SUBJECT: Entergy Nuclear Operations, Inc.
Pilgrim Nuclear Power Station
Docket No. 50-293 License No. DPR-35
License Renewal Application Amendment 16

LETTER NUMBER: 2.07.027

Information in Response to the Open Items Listed in the Draft NRC SER,
Including Associated LRA Amendments and License Condition

Figure 1: Correlating concrete construction sequence with water seepage occurrence: The dashed lines represent construction joints (re-constructed from shop-drawings), the patches represent observed water seepage in specific bays.

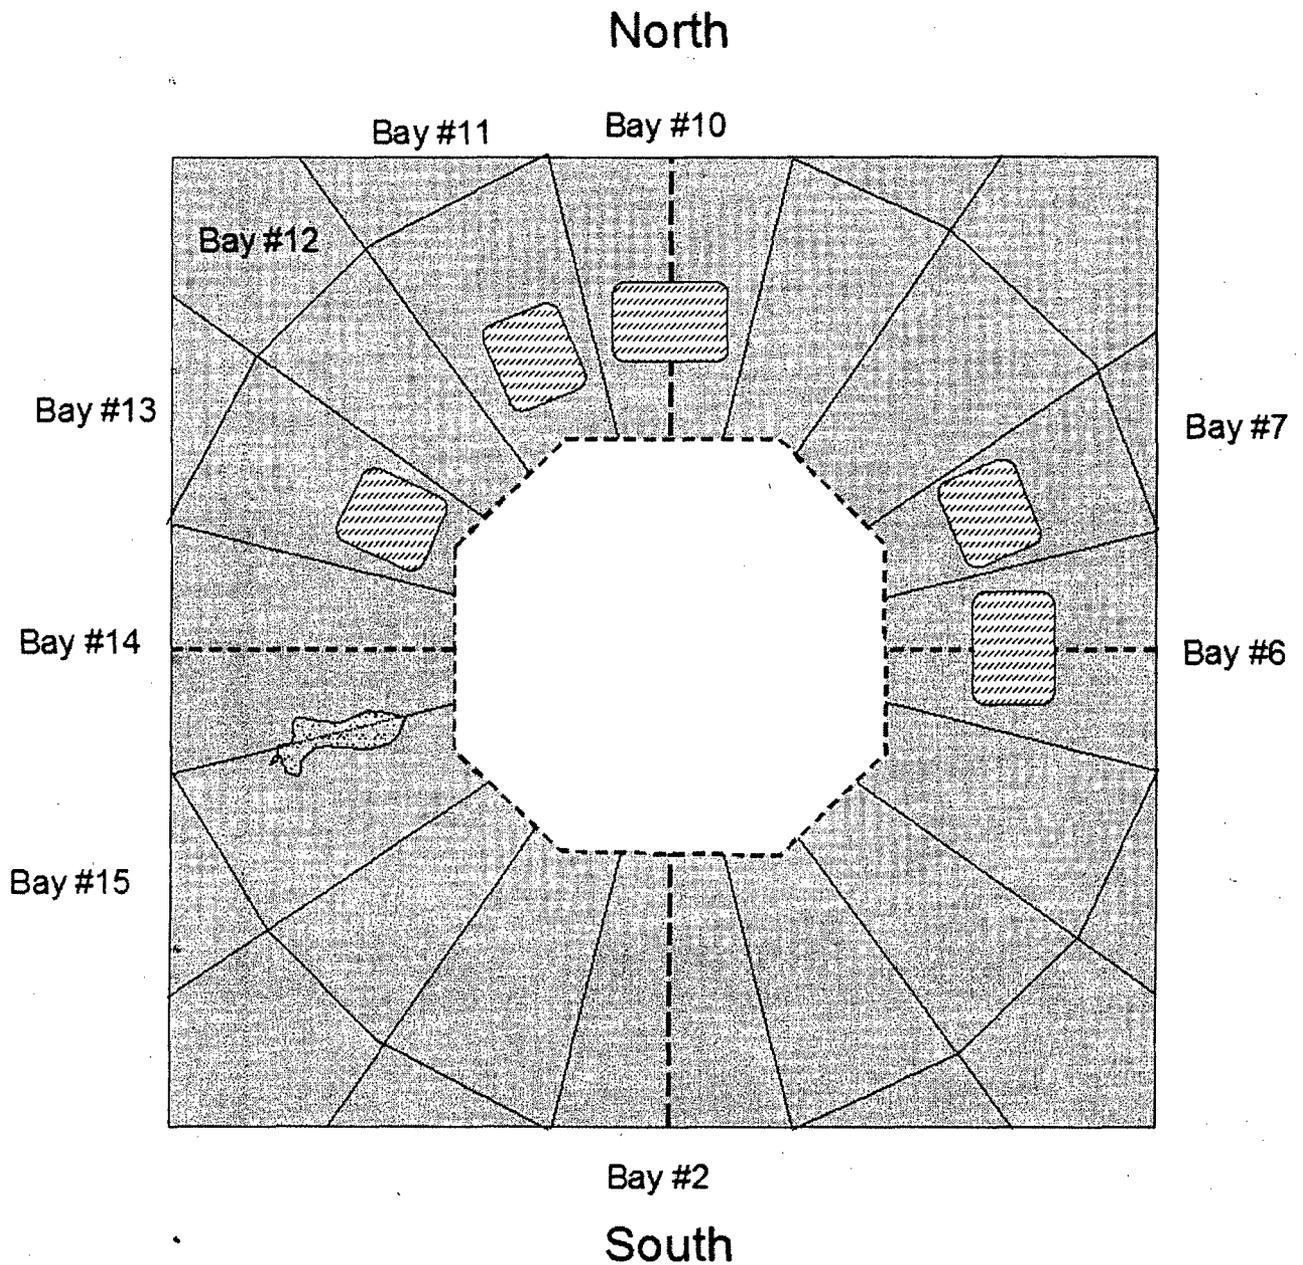
In order to check this suggestion, Figure 1 overlays in a plan view the pouring sequence with concrete joints and the bays in which water seepage has been observed. There appears to be a clear correlation between the construction sequence and the locus of occurrence of water. In particular:

- (1) In bay #6 and #10, it is most likely that the water seepage originates from the 'T' junction of the mat-mat joint with the core-mat joint.
- (2) The fact that the core foundation was constructed only after the mat may have had some important implications on the stresses that were most likely generated during the concrete hydration. In fact, since hydration is an exothermic reaction, heat is generated during hydration, which leads to high temperature rises in massive concrete elements. This heat is transported through the concrete surface leading to a cooling over time of the concrete, until the concrete element reaches the ambient temperature [1]. Given the construction process, the base mat which had been poured first, must have been already in a state of cooling, when the much thicker core foundation was poured. Given the massive dimensions of the core foundation, the temperature in the core foundation is expected to have followed an almost adiabatic temperature rise. This temperature differential between the cooler mat and the hot core generates circumferential tension stresses in the mat immediately adjacent to the concrete joint. Indeed, a rough analysis of the stresses surrounding the core foundation shows that the circumferential (or hoop) stresses in the immediate vicinity of the joint are in tension if the temperature rise in the core had been twice the temperature rise in the mat. These stresses are amplified, in bay #7, #11, #13 by the presence of the wedge-shaped joint, leading to a significant stress amplification due to stress concentration which is typical for geometrical discontinuities. It is, therefore most likely that those wedge-shaped corners may have been additionally weakened during the differential hydration, forming some preferential path for water seepage.

- (3) The fact that most water seepage observed occurred on the North side may well be related to the direction of water flow below the foundation, flowing towards the sea situated on the North side.

Figure 2: Estimated equivalent cylindrical joint size as a function of the wetted surface area. The upper curve is based on water re-appearance within one day, the lower curve on water re-appearance in two days.

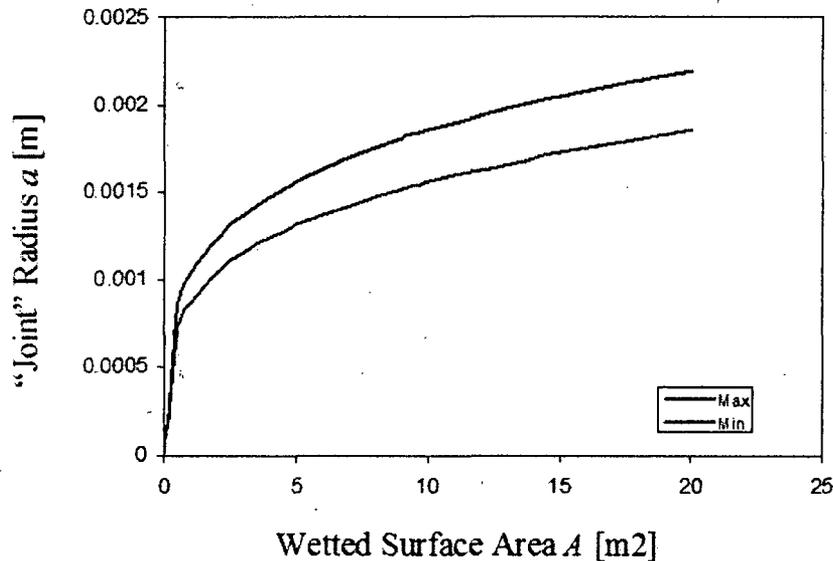
One can attempt to link this high flux rate to the space through which the flow occurs, by considering the flow of water through a cylinder of radius a in a cross section A (see, for instance [5]). In this simple model representation of the flow along the joints, the cylinder represents the joint opening, while the cross section represents the wetted surface in consequence of the flow through the cylinder. These calculations provide an upper-bound estimate of the cylinder radius representing the characteristic size of the joint opening, and yield values for the pore throat radius in functions of the wetted surface area. The results which are displayed in Figure 2, indicate that the equivalent cylindrical "joint" opening, is on the order of 1-2 mm (~1/25 – 1/12 in) for wetted surface areas of 5-20 m² (~50–200 ft²) which was observed in some bay areas.

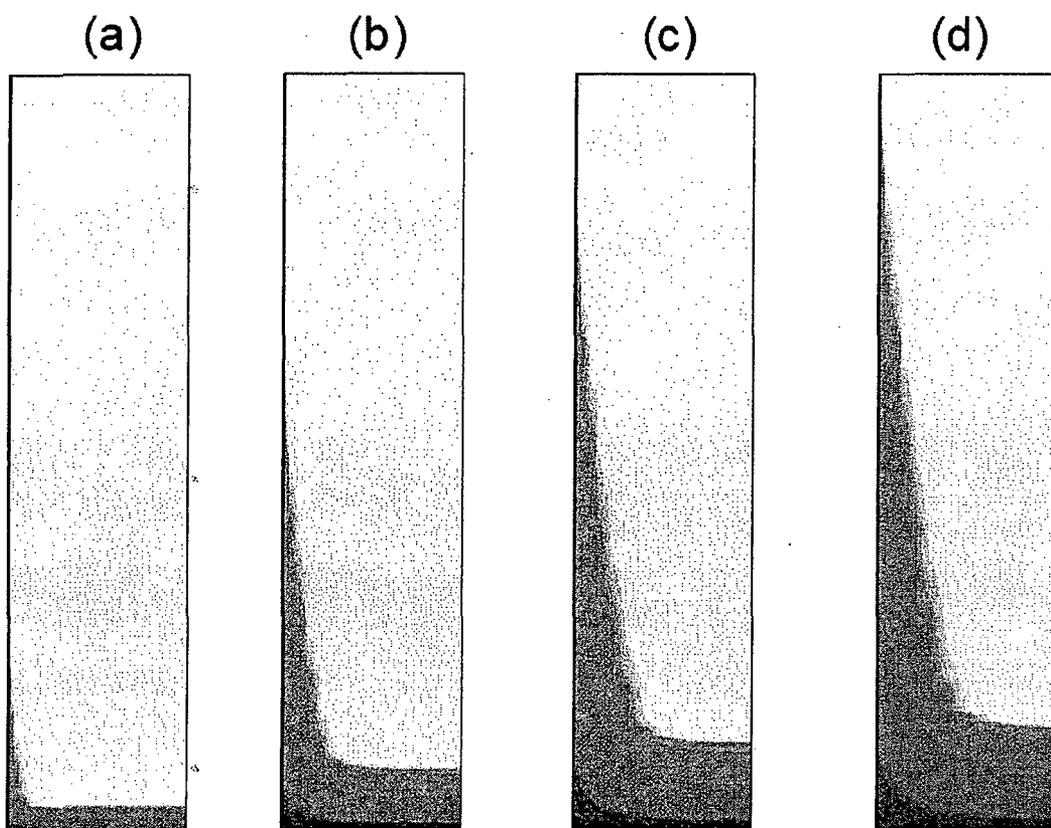
Water collected from the Torus room and analyzed chemically³ showed a calcium concentration of 230 mg/L, which is smaller than the equilibrium calcium concentration. As a consequence, it cannot be excluded that calcium leaching occurred along the preferential path of groundwater intrusion. In favor of this suggestion is the observation that evaporation residues furthermore show a 31mw% of calcium⁴.

Fortunately, calcium leaching is a very slow process: the calcium leaching front advances 0.115 mm/ $\sqrt{\text{day}}$; which means that over the last 35 years the leaching may have dissolved the calcium in a layer maximum 13 mm (~1/2 in) thick. In other words, in the life span of the power plant, calcium leaching has no effect on the bulk integrity and structural performance of the concrete foundation. On the other hand, it cannot be excluded that calcium leaching may have contributed to the weakening of the construction joints over the years. In fact, the calcium leaching may have contributed to the joint opening through which groundwater (at a lower calcium concentration than the equilibrium concentration) penetrates. The way by which calcium leaching is most likely to affect the joint opening is sketched in Figure 3, showing dissolution fronts originating from the bottom side around a joint (left). The figure shows that the dissolution generates a vertical wedge-shaped dissolution pattern around the joint, which propagates upward through the slab in a self-similar fashion. These dissolution fronts scale linearly with the water-velocity in the joint and the joint opening [9]; which means that the higher the water flow through the joint, the more advanced the vertical position of the degraded zone.

Figure 1: Pressure Test P-T Curve (Curve A) for 54 EFPY with Bias CF on Fluence [8]

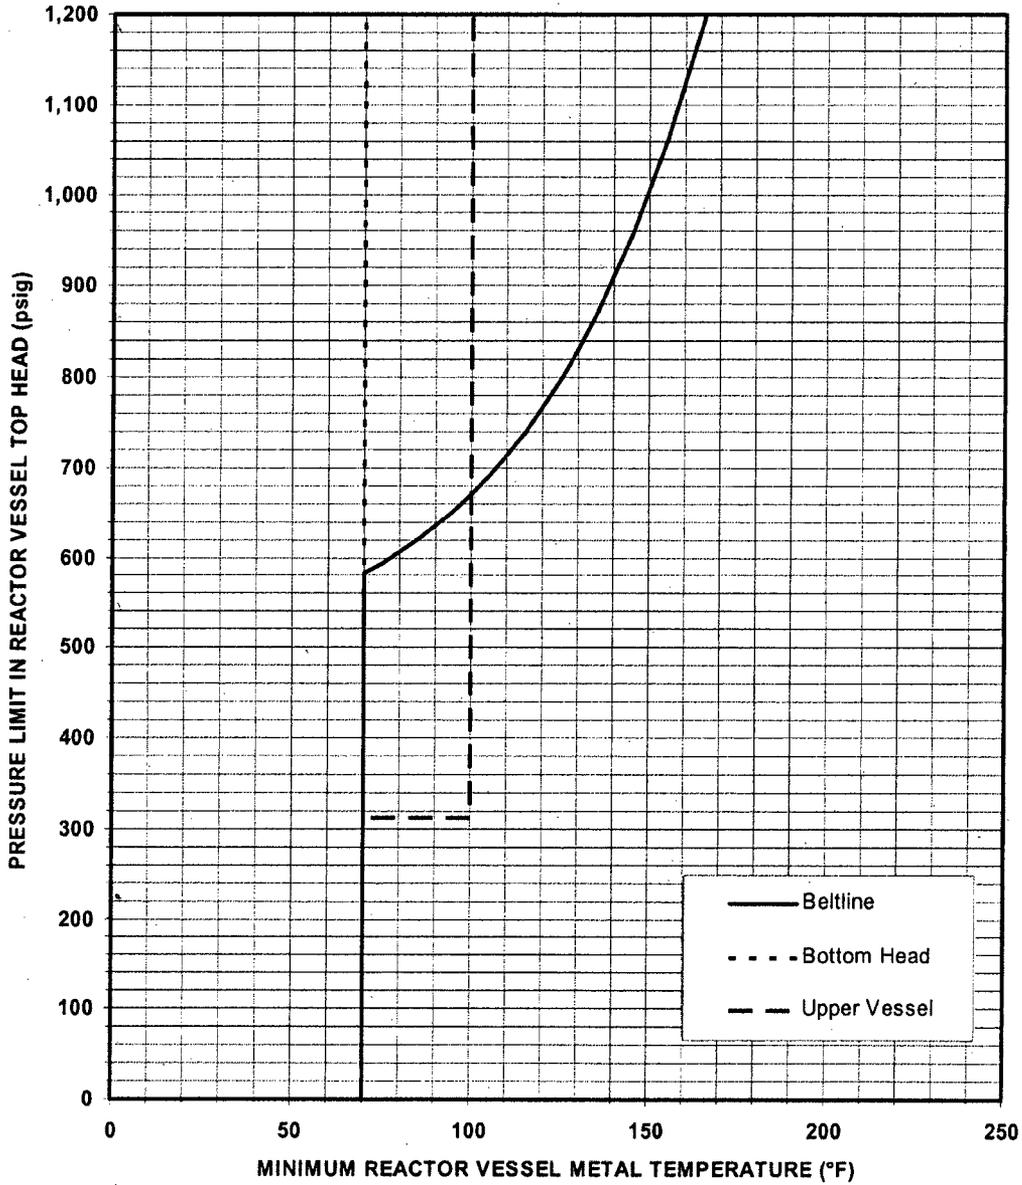
The recent fluence re-evaluation for the Pilgrim Nuclear Power Station (PNPS) reactor pressure vessel (RPV) using the EPRI RAMA code required an increased fluence bias correction factor (CF) of 1.78 to adjust for the benchmarking discrepancy with the cycle 4 surveillance capsule dosimetry results [1]. A rigorous technical explanation for this bias has not been determined. As a result, the NRC will not accept the PNPS fluence calculations for application to future plant operation without further justification. In response to this, Entergy Nuclear Northeast (ENN) has requested SI to perform an additional evaluation to demonstrate adequate vessel life prediction through the extended 60-year operating period with respect to the fluence projections.

Irradiation by high energy neutrons raises the RT_{NDT} of the reactor vessel materials. The ART is defined as $RT_{NDT} + \Delta RT_{NDT} + \text{Margin}$ in accordance with Regulatory Guide 1.99, Rev. 2 [7]. The pressure-temperature (P-T) curves are developed from the ART value for the vessel material. The calculated hydrotest pressure vs. temperature curve (Curve A) results for 54 EFPY are shown in Table 1 and in Figure 1 [8]. The PNPS projected values for ΔRT_{NDT} and ART at 54 EFPY were calculated with the 1.78 bias correction factor on fluence [9]. The projected values of ART are shown in Table 2. The hydrotest pressure is the normal operating pressure, which is 1,035 psig [10]. The system hydrostatic test temperature is calculated to meet the requirements of ASME Section XI, Appendix G, Article G-2400 [2]. The system hydrostatic test should be performed at a temperature not lower than the highest required temperature for any component in the system. For PNPS, the limiting component is the beltline

**Figure 3. Predicted Decrease in Upper Shelf Energy as a Function of Pct. Copper and Fluence
(from Reg. Guide 1.99, Rev. 2 [7])**

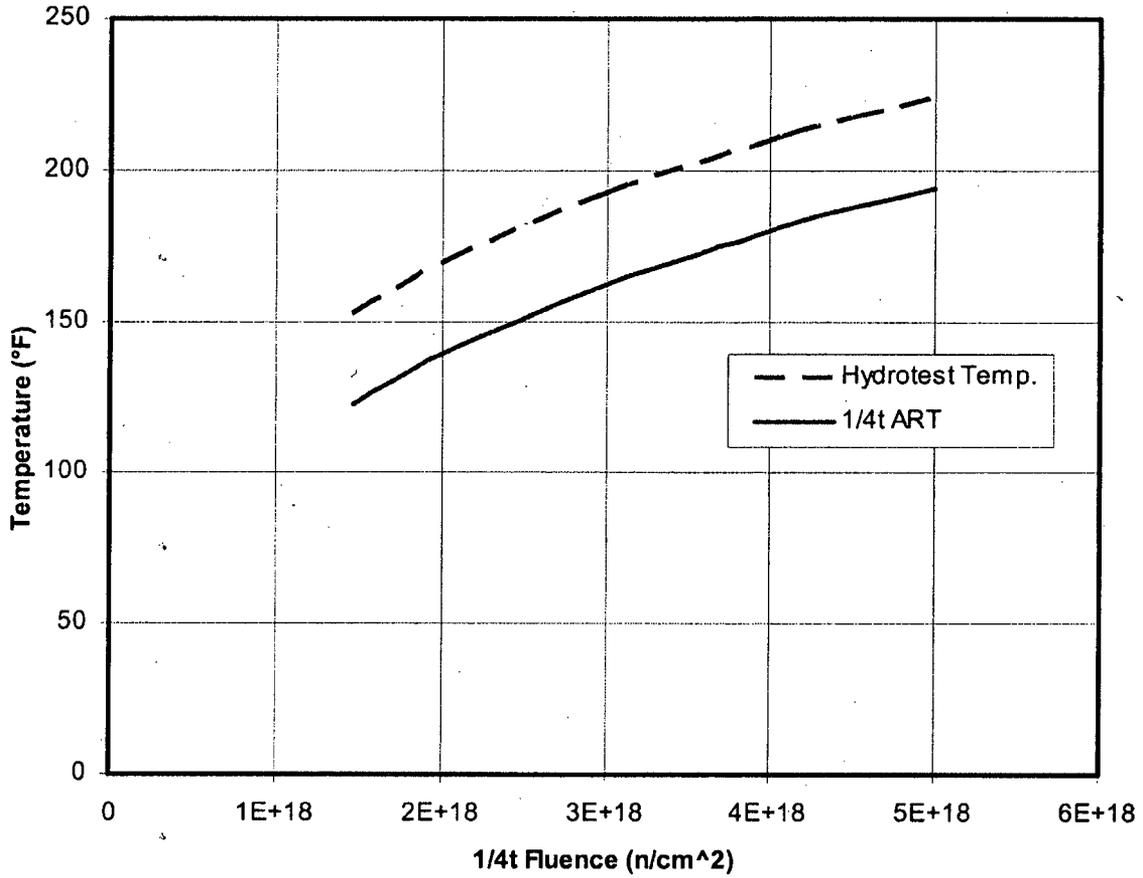
Appendix G of 10CFR50 requires that reactor vessel beltline materials “have Charpy upper shelf energy...of no less than 75 ft-lb initially and must maintain Charpy upper shelf energy throughout the life of the vessel of no less than 50 ft-lb.” Regulatory Guide 1.99, Rev. 2, *Radiation Embrittlement of Reactor Vessel Materials*, defines the method for predicting upper shelf energy drop in terms of a percentage from the unirradiated value. Figure 3 shows the predicted Charpy upper shelf energy for welds and base metals as a function of copper content and fluence.
